Access Compliance Report

Public Rights-of-Way

Intersection ID: 7131	Main Street: N_TRYON_ST	Cross Street: ORCHARD_TRACE_LN	Location: W
ADA ID: 1DB24B7D0929	Ramp Type: Directional1	Initial Pass/Fail: Fail	Overall Compliance: No
Severity Score: 12.5			
Codes/Mitigation Info/Possible Solution		Field Measurements/Component Compliance

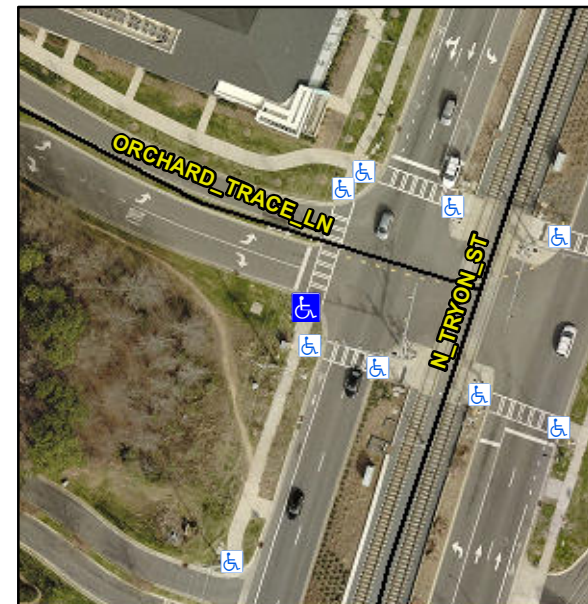
R304.2.2

Remove & Replace Entire Ramp.
